From: [Olk, John](#)
To: [Daly, Keith](#);
cc: [Green, Frank](#); [Peppers, Nicki](#);
Subject: RE: Air System Shop Drawings For Contract 8078 Columbia River Bridge Temporary Pile Test Program
Date: Tuesday, February 01, 2011 11:11:10 AM
Attachments: [8078 - Air Supply Manifold & Hook Up Working Drawings.pdf](#)

APPROVED AS NOTED

AMERICAN CONSTRUCTION
 UNCONFINED BUBBLE CURTAIN
 AIR SUPPLY MANIFOLD

DESIGN: wpease	APPROVED: [Signature]	APPROVED BY LETTER DATED: [Signature]	DATE: 28 JAN 11	SCALE: NOTED	REV: A
DWG NO. 1109-100-2	SHEET 1	OF 2

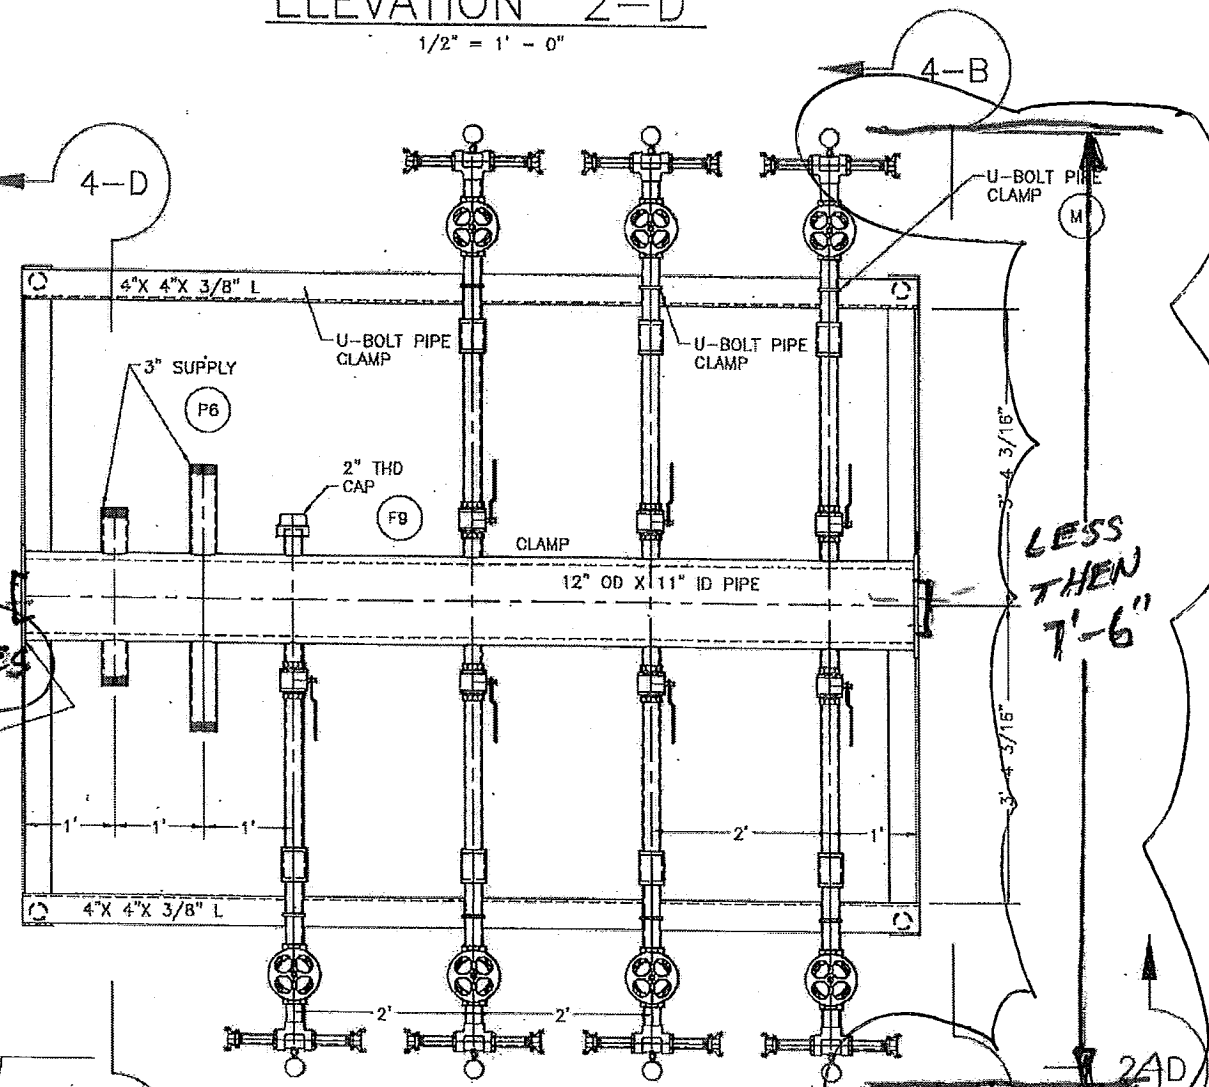
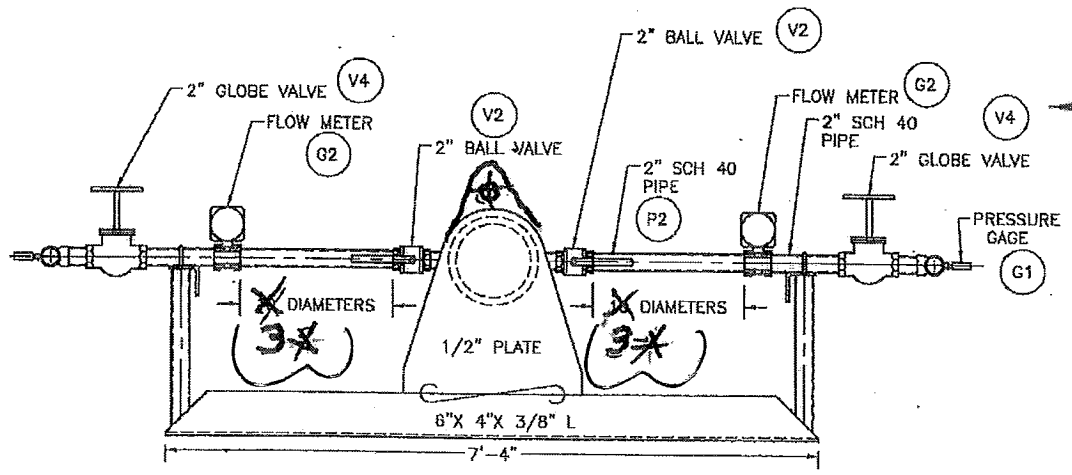
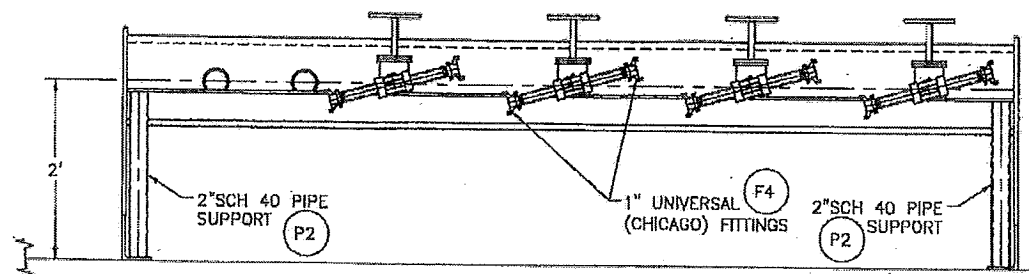
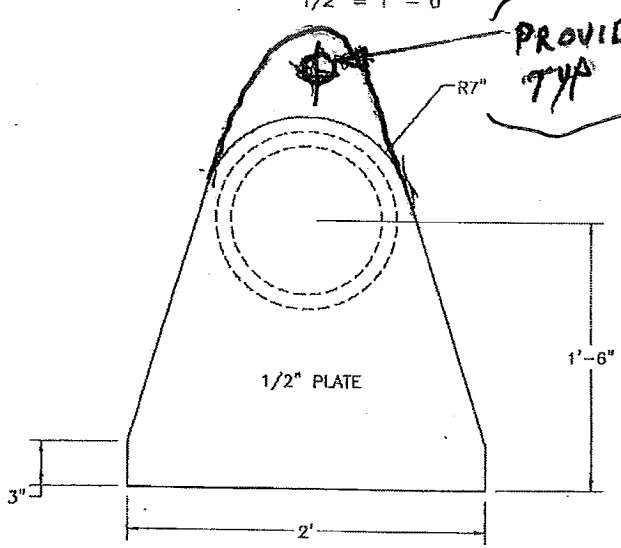
Paint steel components per
 std spec.
 per plan sht 8.

DRILL AND TAP
 FOR 1/2" NPT PLUG

PROVIDE LIFTING EYES
 TYP 2 PLACES

* FLOW METER SUPPLIER OK'D FEWER DIAMETERS

DESIGN	WPROB8	APPROVED	APPROVED BY LETTER DATED
CHECKED		DATE 28 JAN 11	OWNER
DWG NO. 1109-100-2	SHEET 2	of 2	SCALE: NOTED

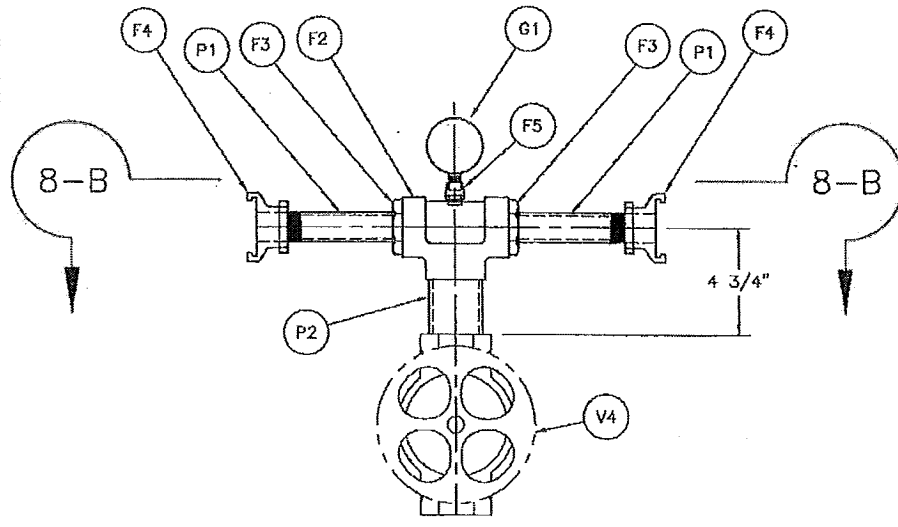
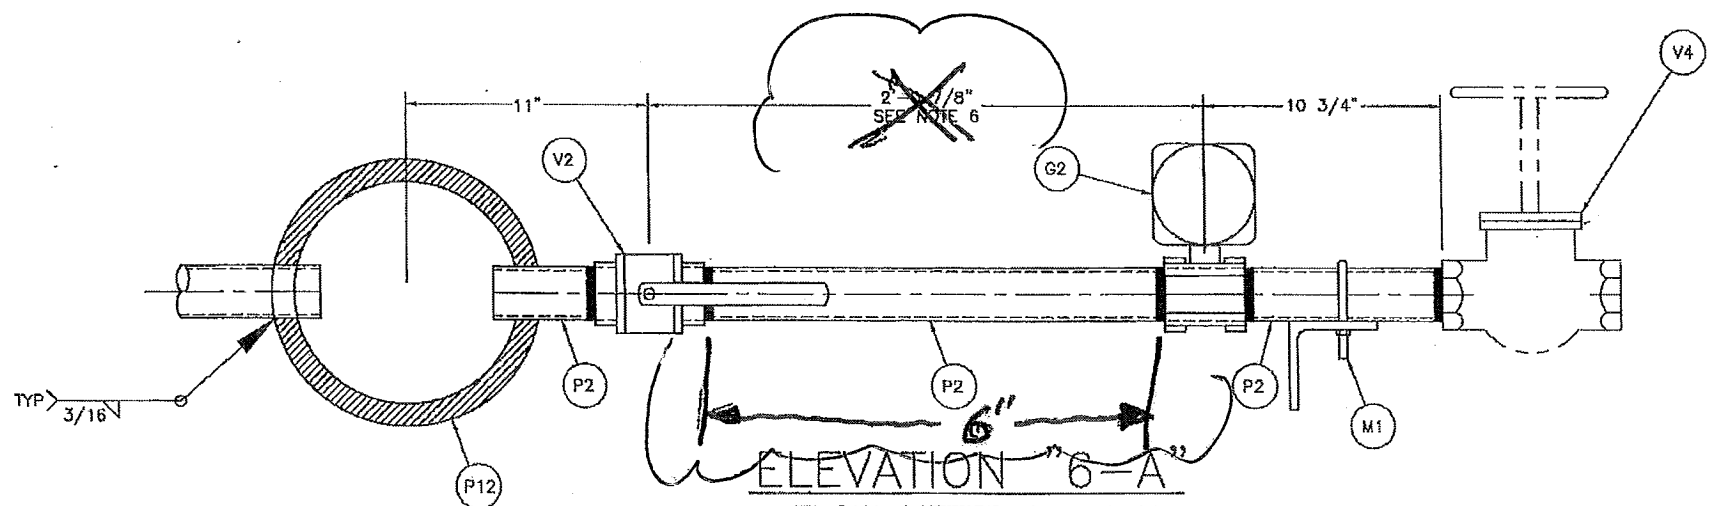
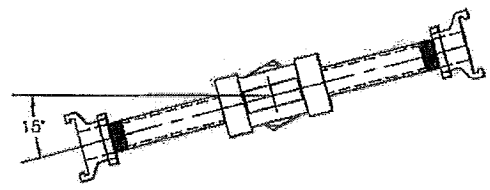
Paint steel components per Std. Spec. per plan sht. 8
